Sandy City, Utah

Planning Commission

Thursday, April 3, 2025

Agenda Item Title:
9000 S. C-Store (Preliminary Site Plan Review)
694 W. 9000 S. St.
[Community #1, Northwestern Exposure]

Gas Pump Canopy and Electric Vehicle (EV) Charging Stations

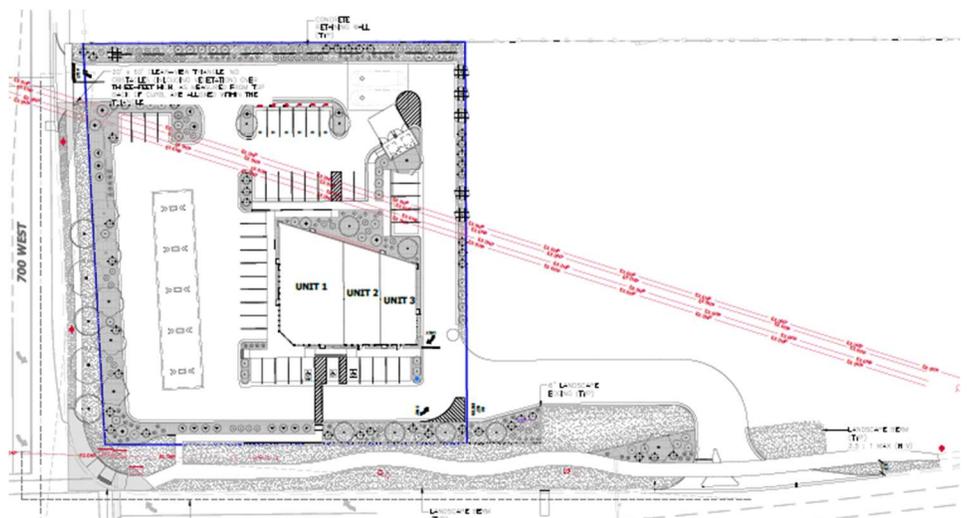
The proposed gas pump canopy structure is 134 feet long north to south and 26 feet wide west to east. It will provide 10 vehicle stalls in a single bay design. This is due to the limited site layout distance between 700 W. St. and the parking stalls located in front of the proposed convenience store. The canopy structure is long, but the single fueling stall depth will reduce the normal canopy depth significantly. This will help prevent the gas island canopy from overwhelming the site and the retail building and is therefore justifiable. There will also be 6 (EV) charging station stalls on the north side of the power transmission line easement. This is the first new fueling station to incorporate EV charging stations to be proposed in Sandy and will aid in building up the charging infrastructure for electric vehicles in the city.

4. Required building wall articulation be reflected on the site plan to match the building elevations drawings.
5. That landscaping plant material be added to screen the proposed EV charging equipment.

SHEET NO. **C1.00**

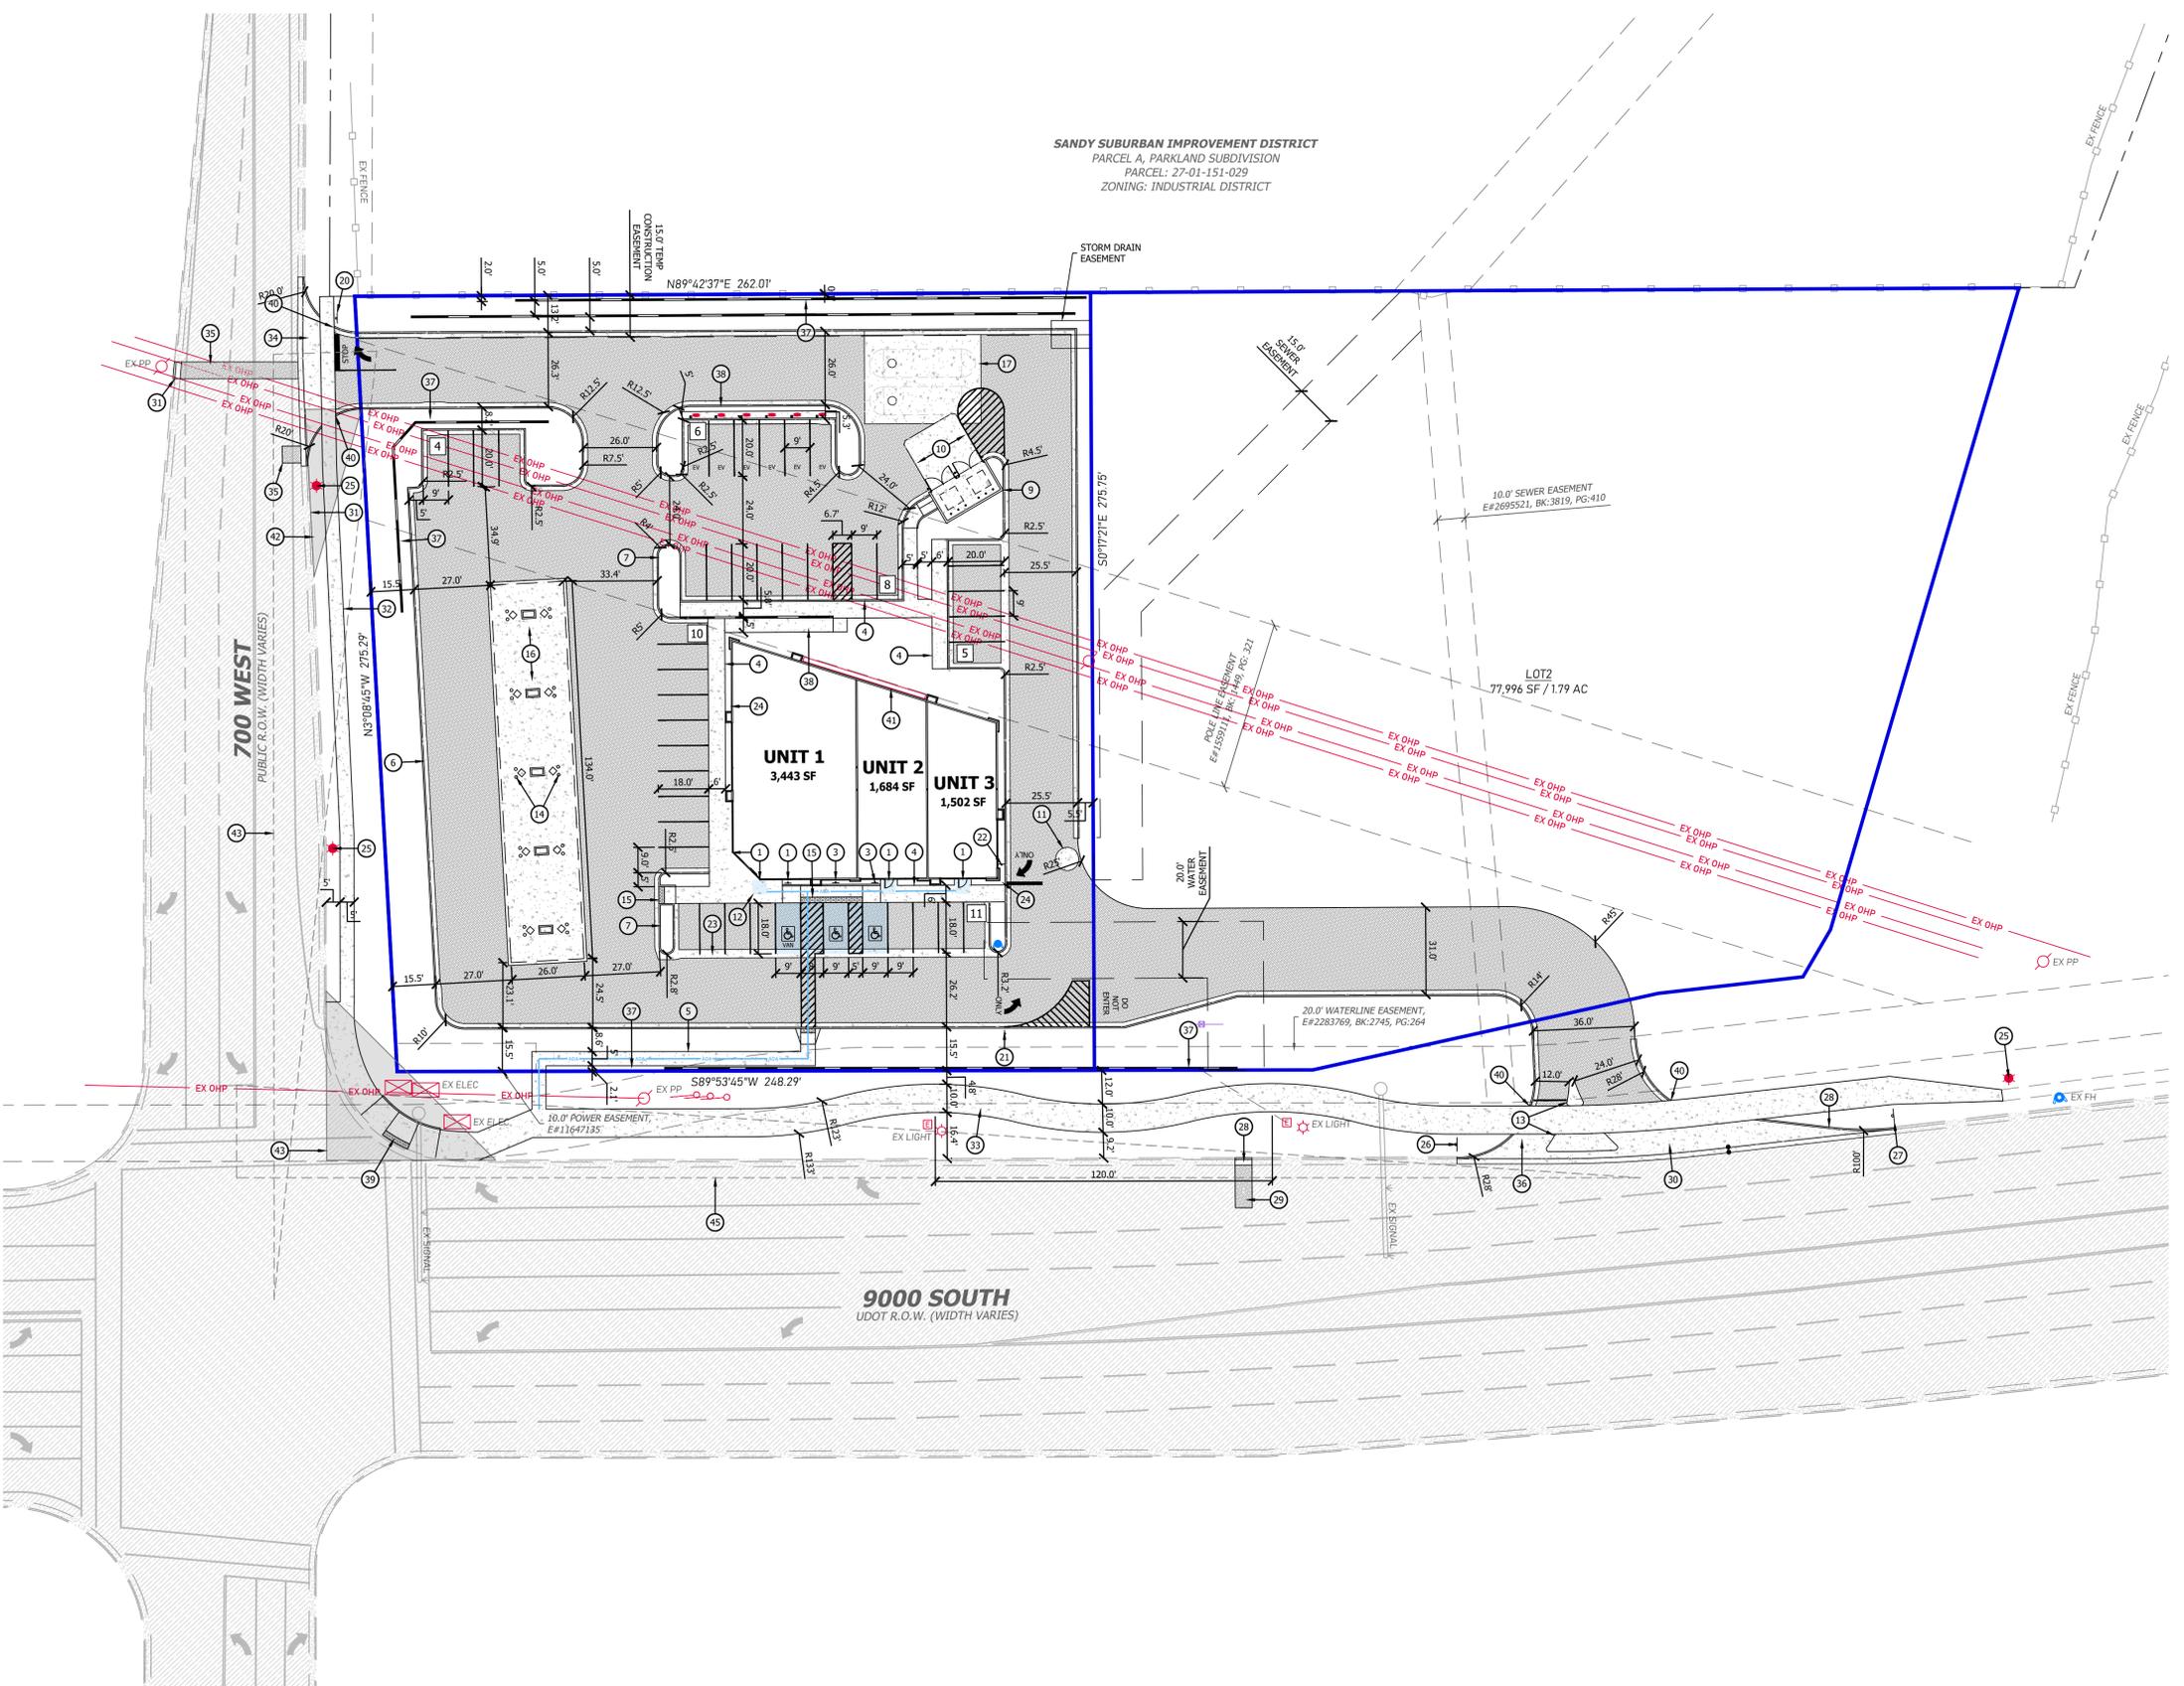
1. That the development complies with all Building & Safety, Fire and Life Safety Codes applicable to this type of use.
2. That the site plan be altered to remove four Community Development Director approves the 10 percent increase in the required number of parking stalls to be provided on site.

3. That stubbed driveways be shown on the final plans and constructed with the site improvements on the north boundary and the east boundary of the lot, as determined by the city engineer.

6. That street trees spaced at 35' on center be included in the final landscape plan along the right of way of both public streets.
7. That functional windows and/or spandrel glass windows be added to the north building wall to provide better four-sided architectural treatment.

8. All utility boxes (i.e. transformers, switchgear, telephone, cable TV, etc.) shall be shown on the site plan and shall be placed underground or moved behind the front setback of the buildings and screened from view. Each box shall be shown in its exact location and shall be noted with its exact height, width and length. Building utility meters shall be mounted to the side or rear elevation or screened and painted to match the building background colors.

North Exterior Elevation (Rear)

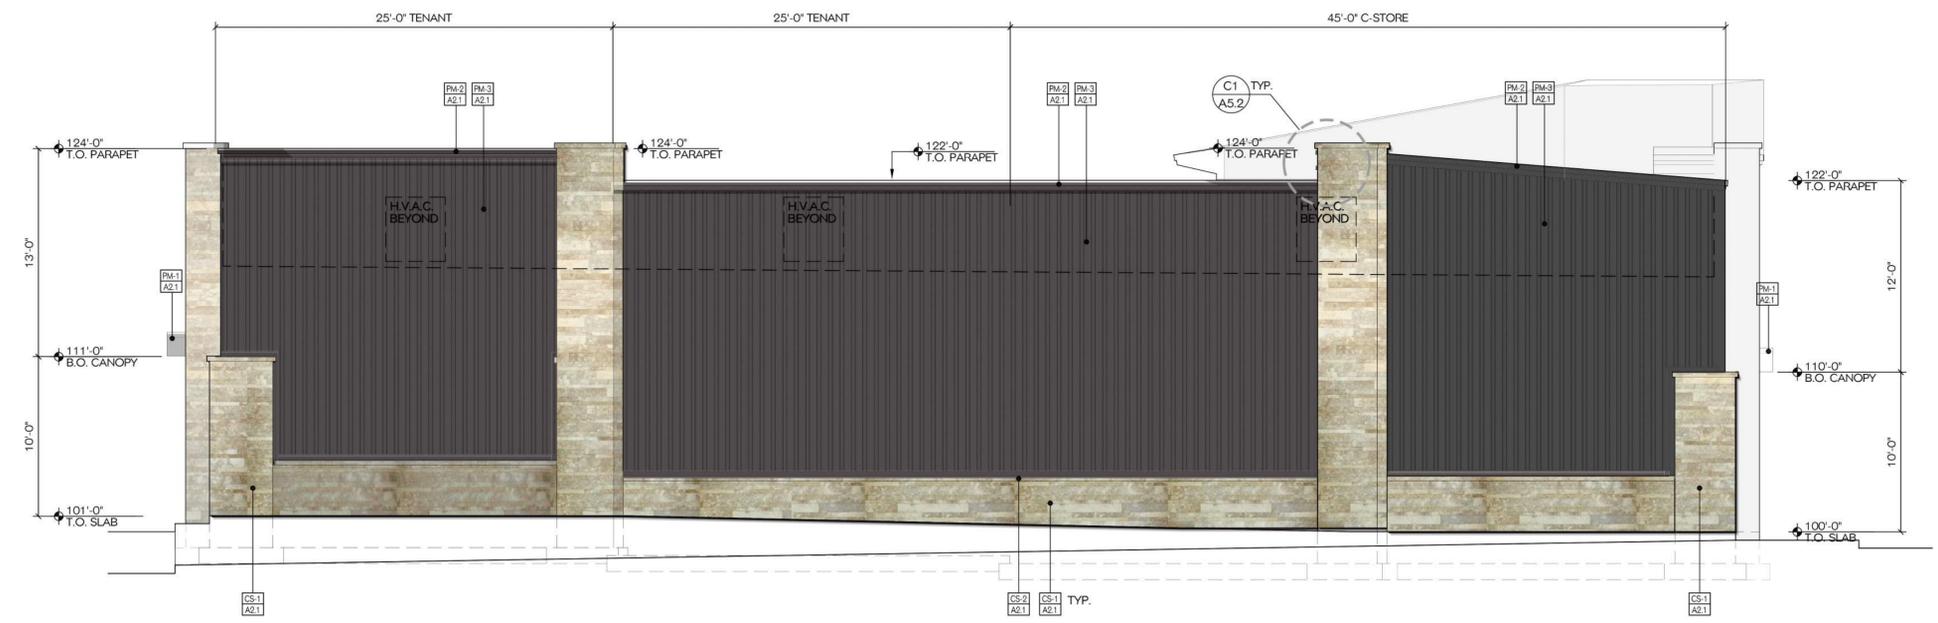
The proposed single story, 6,630 square foot building is of a modern design, with a flat roof and varying height, angled and raised parapets. The building materials are arranged to add interest to the building with vertical columns and horizontal segmenting, using various materials and colors. (Please see the building elevation drawing in the attached (Exhibit A.) Roof top mounted mechanical equipment (RTU) are to be located on the flat roof and will be fully screened by the parapets. Roof drainage will be completely contained within the building walls. There is less than 20 percent EIFS/Stucco material proposed for the building above the entry canopy where the future store signage will be located. Building materials consist of natural stone columns and wainscoting, architectural metal panels and storefront glass windows and some spandrel glass. Colors are grays, tans and cobalt blue accents. The building will meet the Sandy City Architectural Design Standards for commercial buildings as proposed, except for a lack of any windows on the north side of the building.
